July 12, 2022

RE: JMC Project 20044
4 Tripp Lane Gross Land Coverage Compliance Analysis
4 Tripp Lane
Town of North Castle, New York

Response to Town Consultant's Comments

Drawn: DK Approved: AN
 Scale: 1" = 20'
 Date: 03/01/2021
 Project No: 20044
 2004-SE-01 EXIST EXIST.scr
 Drawing No:
C-110
Previous Editions Obsolete

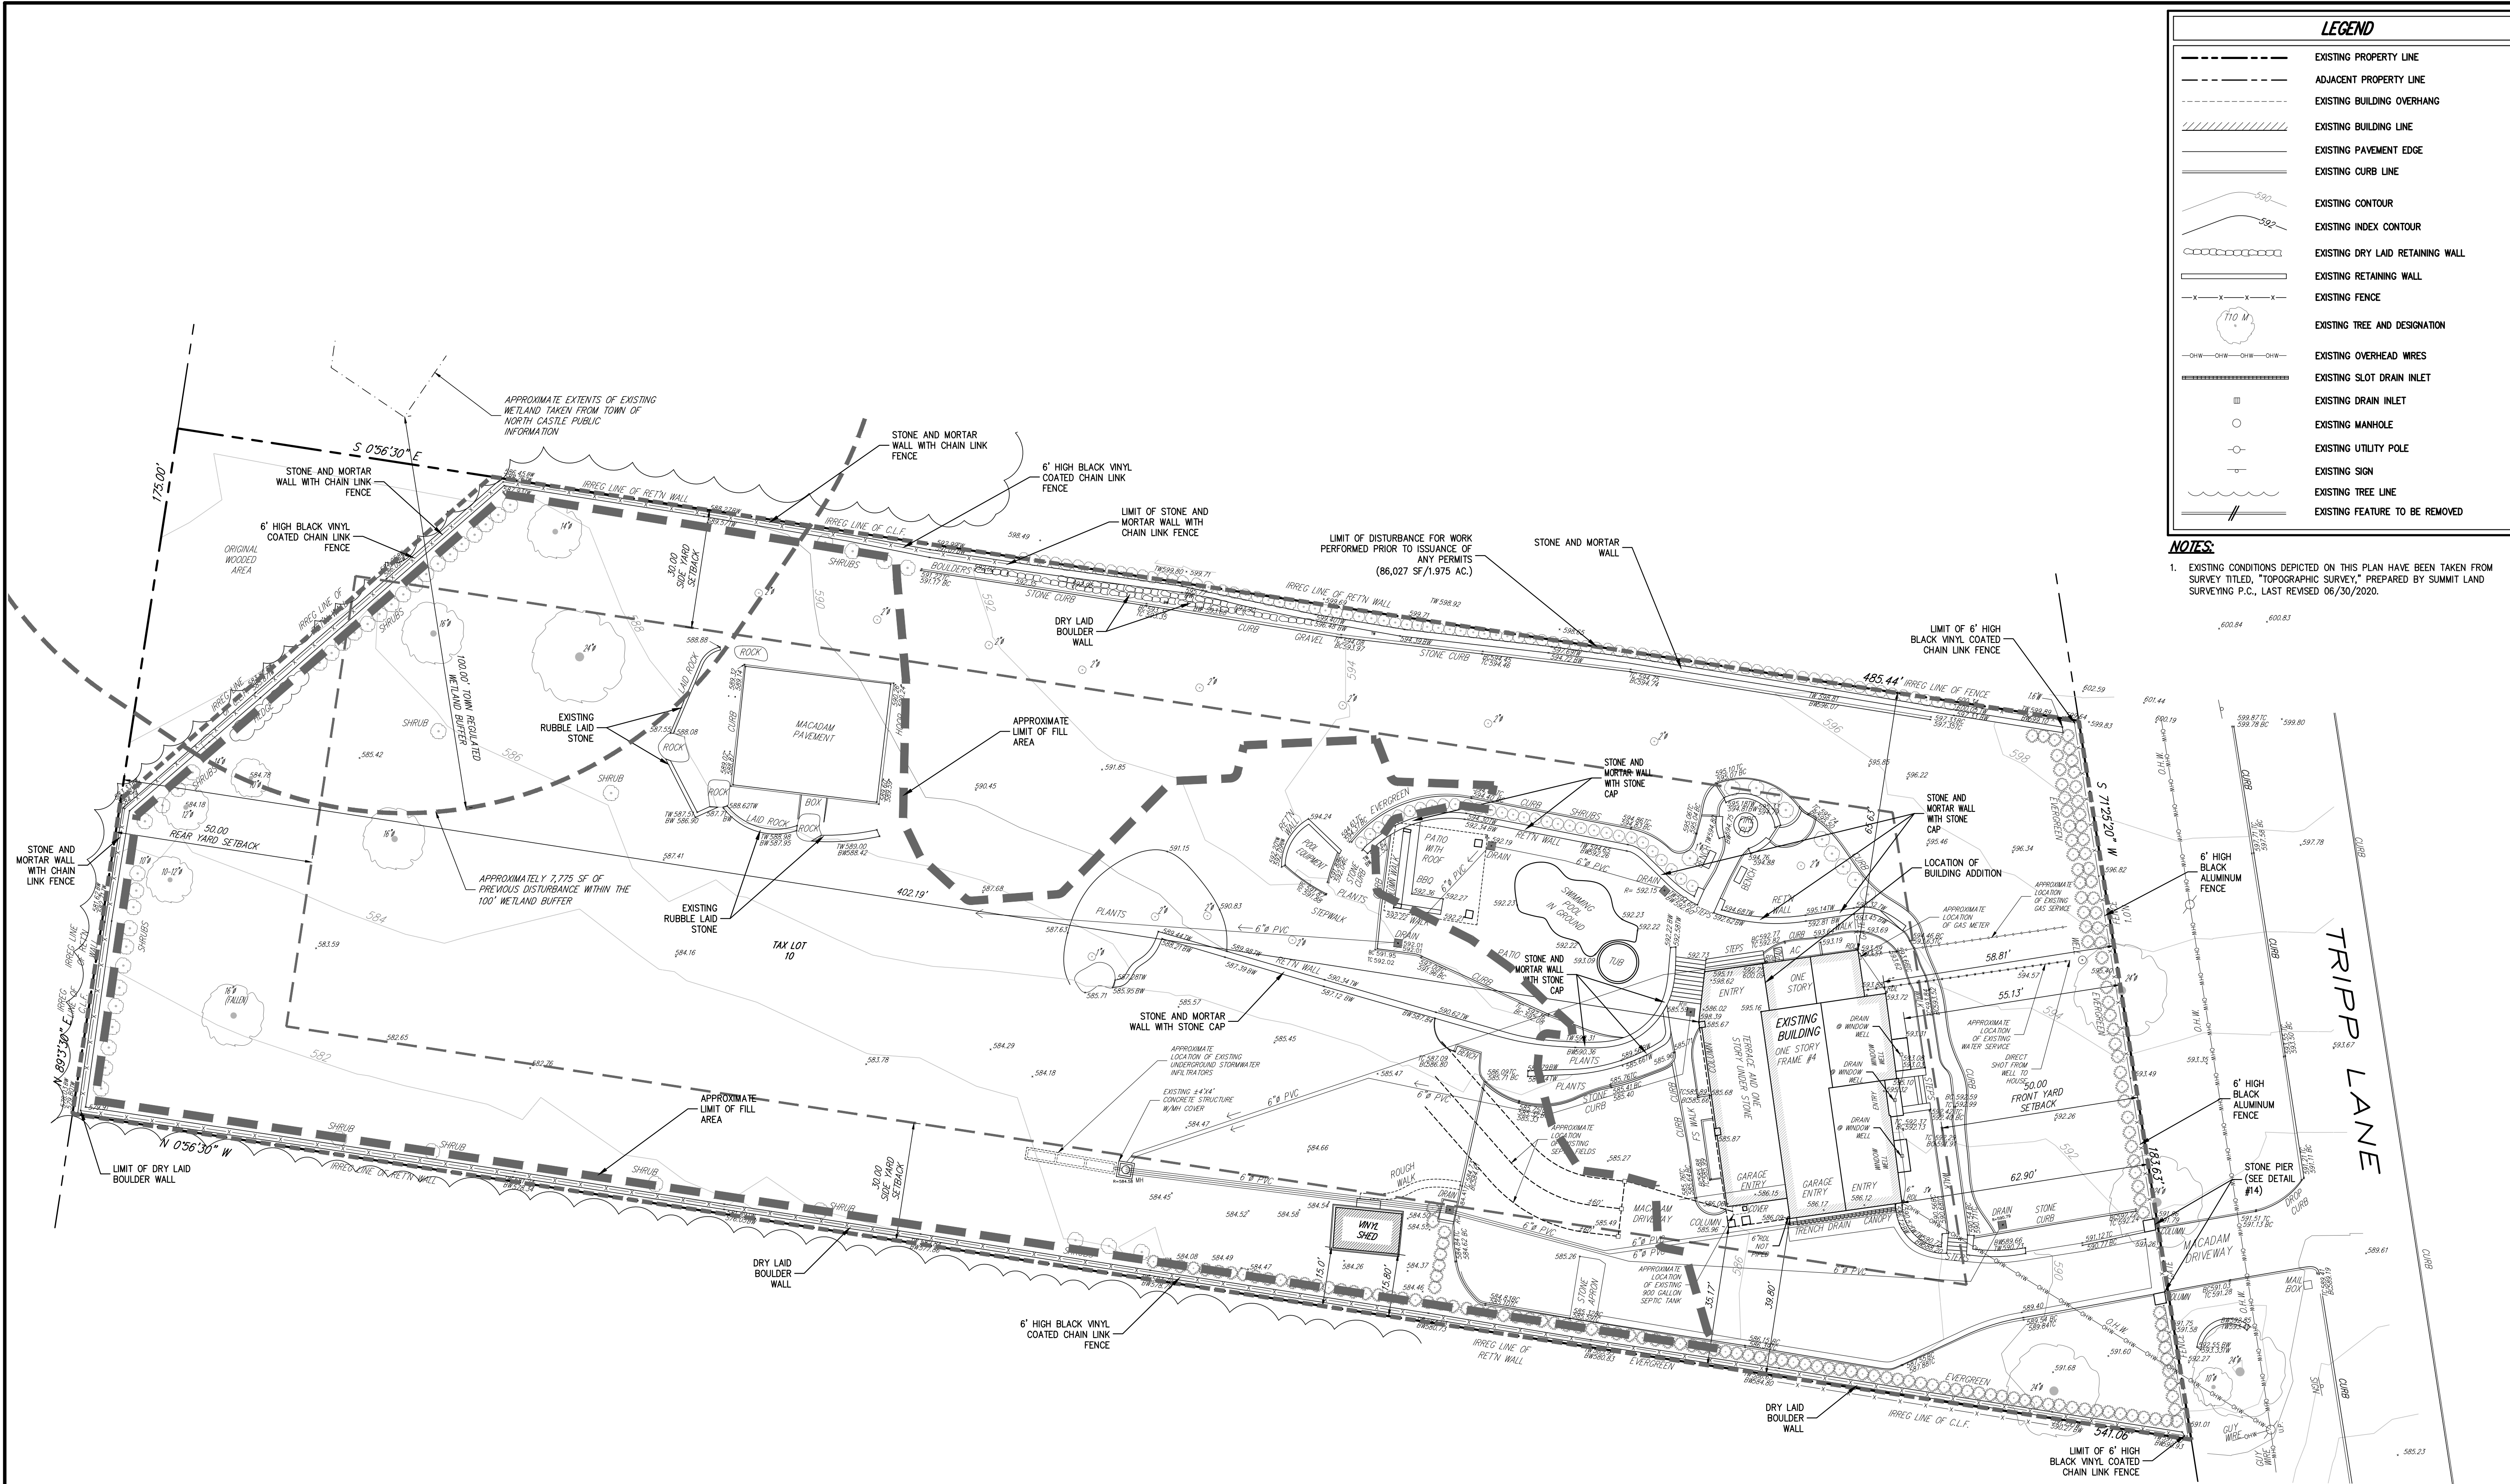
The plan shall illustrate and dimension all minimum required yard setbacks.

The site plan should be revised to depict the location of the proposed (legalization) fence. In addition, a fence detail should be submitted for review.

The site plan should be revised to label the proposed (legalization) driveway entry piers. In addition, details of the driveway piers should be submitted for review.

The site plan should depict the location and height of all proposed (legalization) retaining walls.

JMC Drawing C-110 now illustrates and dimensions all yard setbacks and all conform to Town code.

Survey information was obtained from the Town of North Castle's Planning Board website that included the extents of the town regulated wetland located on the adjacent property. This was the only information available as there is no historical information on this town regulated wetland. This wetland was delineated on April 18, 2022, by Ecological Solutions, LLC. The wetland buffer and the approximate amount of previous disturbance within this buffer are now shown on JMC Drawing C-110.

The only new impervious surfaces within the 100' wetland buffer are the new retaining walls that total approximately 300 SF of impervious area. The approximate amount of disturbance within the wetland buffer is now labeled on JMC Drawing C-110. There was no disturbance to the wetland itself according to the wetland information delineated by Ecological Solutions on April 18, 2022. The applicant awaits determination by the Town on whether a mitigation plan will be necessary based on new information included with this submission.

JMC Drawing C-110 has been updated to label all installed fencing.

The piers are now labeled on JMC Drawing C-110 and Detail #14 has been added to the Site Plan set.

JMC Drawing C-110 has been updated to include labels on all retaining walls.

JMC Drawing C-110 has been updated to show the approximate limit of fill area.

Drawn: DK Approved: AN
Scale: 1" = 20'
Date: 03/01/2021
Project No: 20044
2004-SIE-03 TREE TREELS
Drawing No: **C-130**

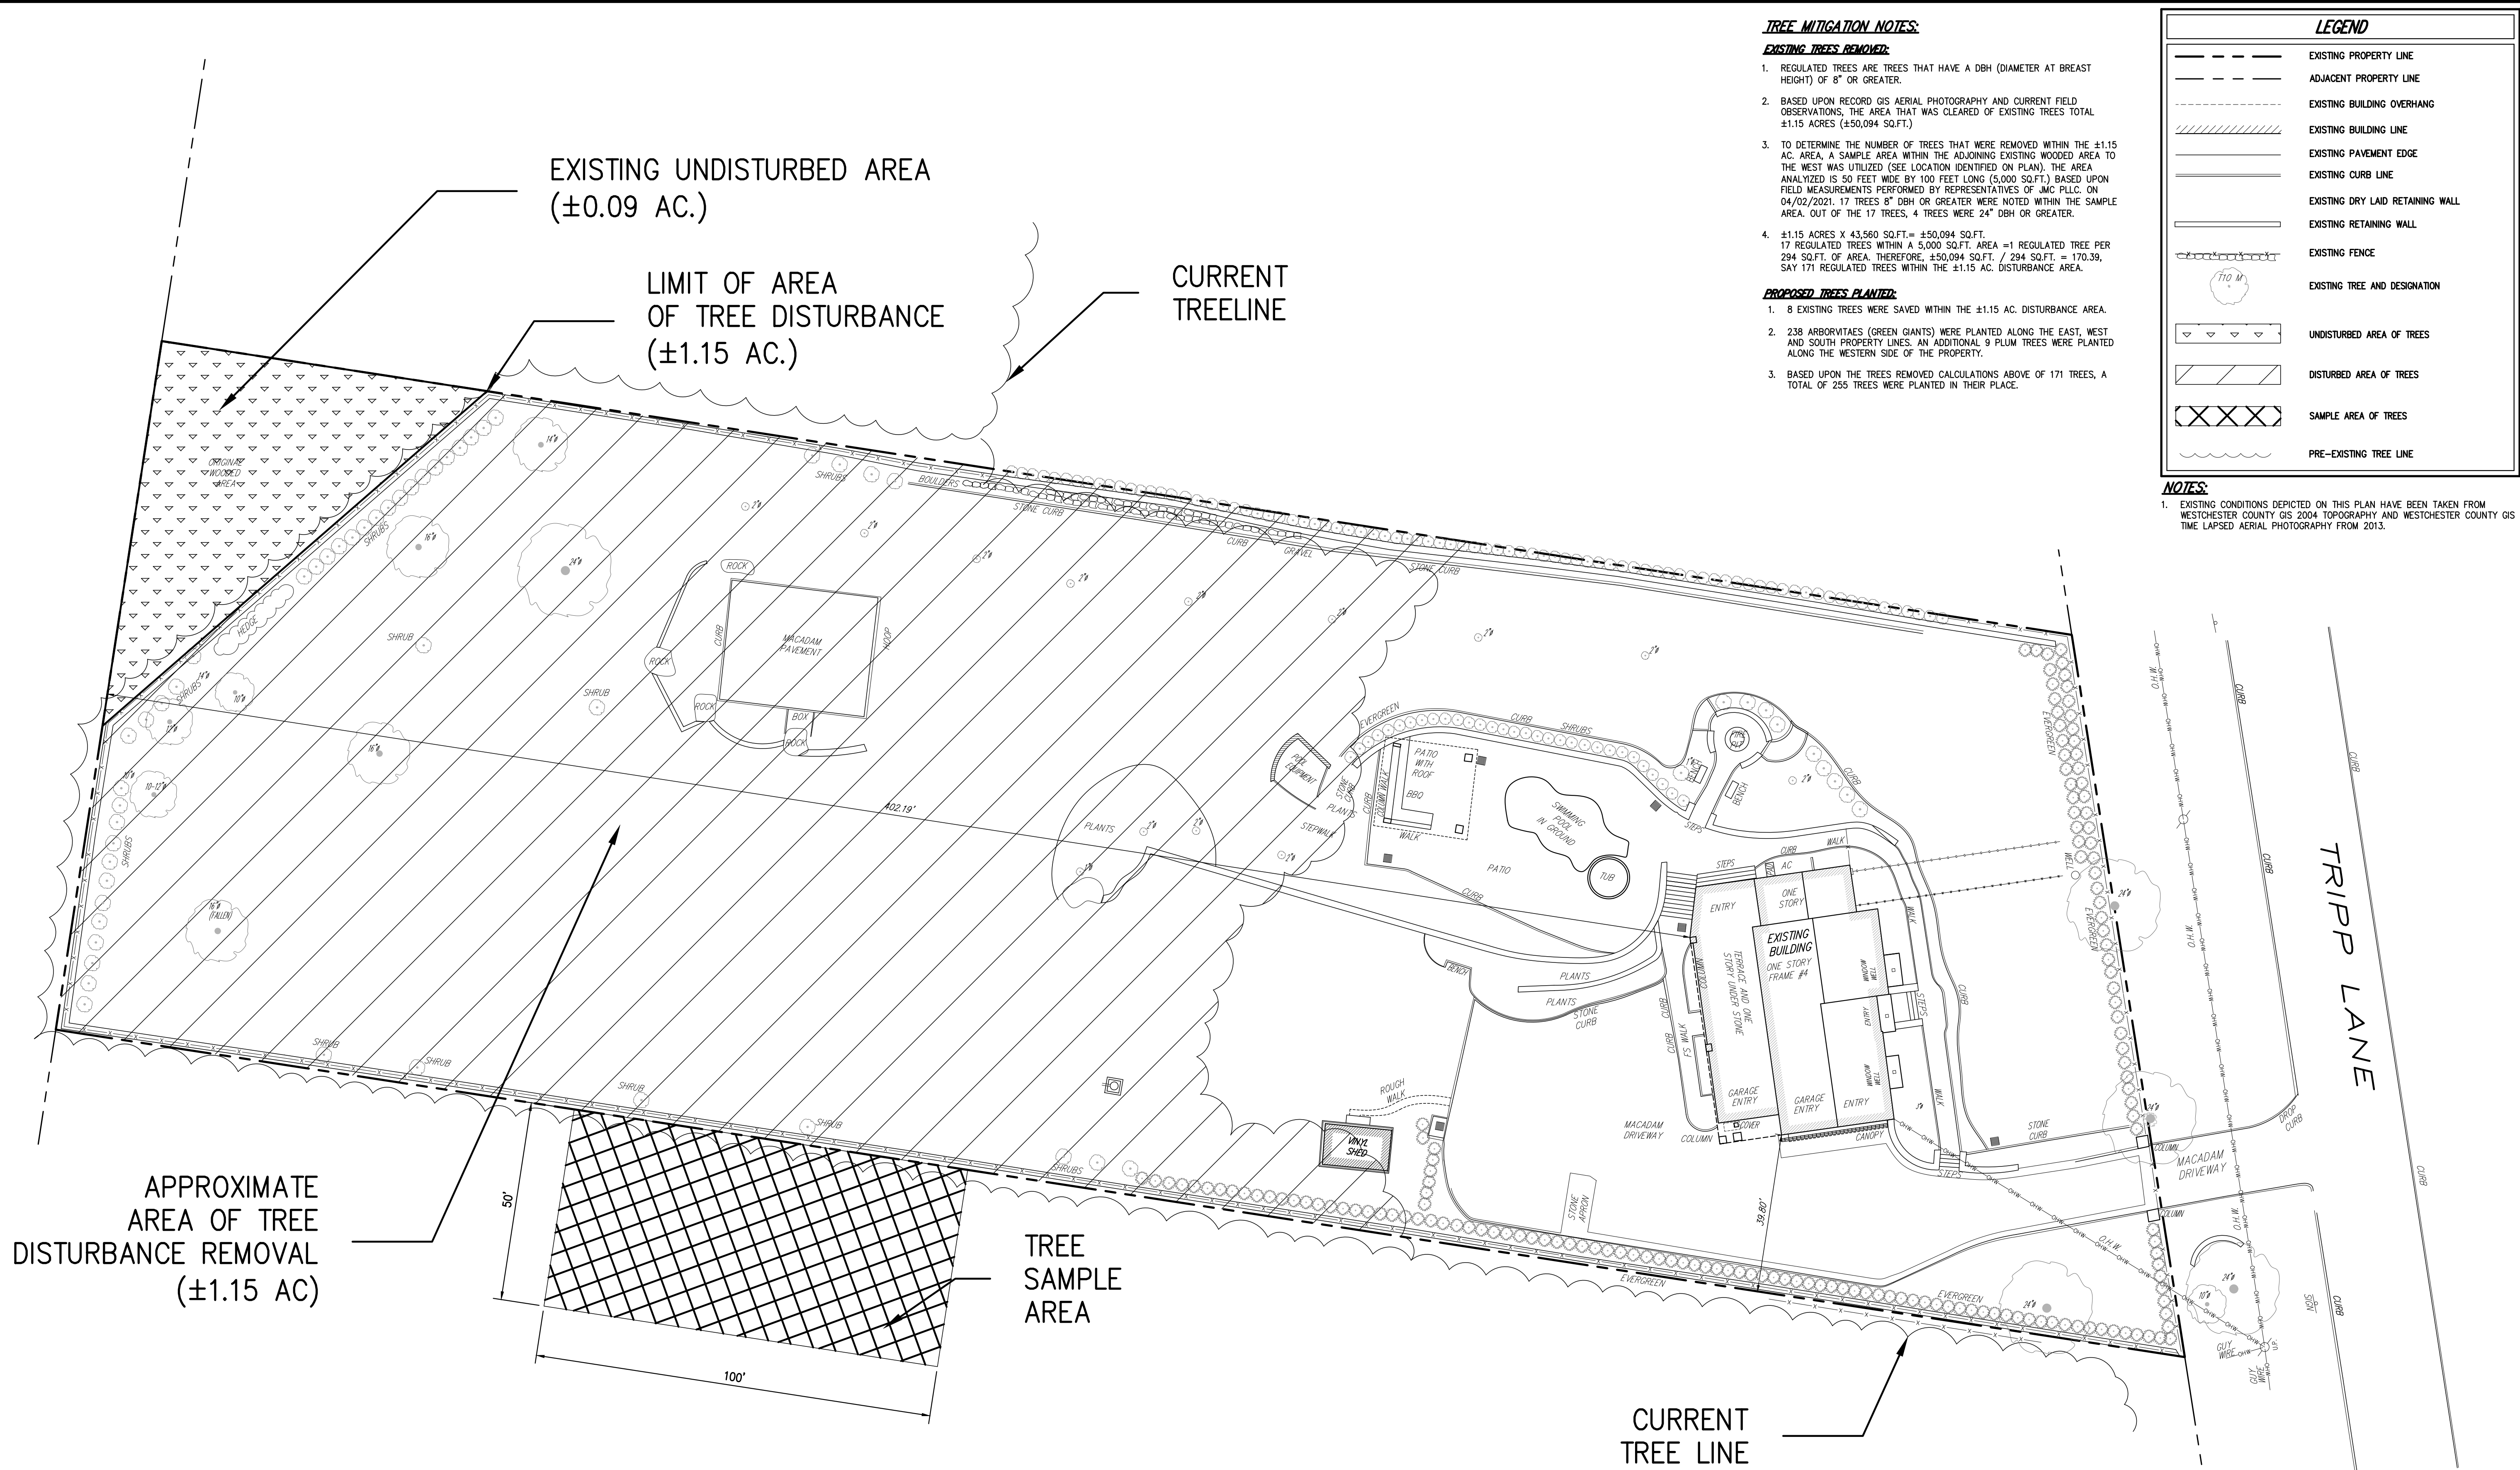
The applicant has cleared a significant number of trees on the property. The quantity, size and species are not known. As required by Chapter 308, Trees of the Town Code, the applicant will be required to provide a tree restoration plan to mitigate the unapproved removal of existing vegetation. The Planning Board will need to determine whether the restoration plan is ultimately appropriate for the level of disturbance.

The site plan should depict the location of the 3/4 acre of trees removed without a permit Pursuant to Section 308-15.A(11) of the Town Code, the Applicant should prepare an extensive tree replanting plan of the disturbed area. The plan should aim to revegetate the site to the maximum extent practicable.

JMC Drawing C-130 has been added to the Site Plan set that delineates the areas of tree removal and proposes a solution for the mitigation of these trees that were removed. The applicant awaits the Town's review and determination on whether the 255 trees that were planted are sufficient for the mitigation of the 171 trees removed.

JMC Drawing C-130 has been added to the Site Plan set that delineates the areas of tree removal and proposes a solution for the mitigation of these trees that were removed. The applicant awaits the Town’s review and determination on whether the 255 trees that were planted are sufficient for the mitigation of the 171 trees removed.
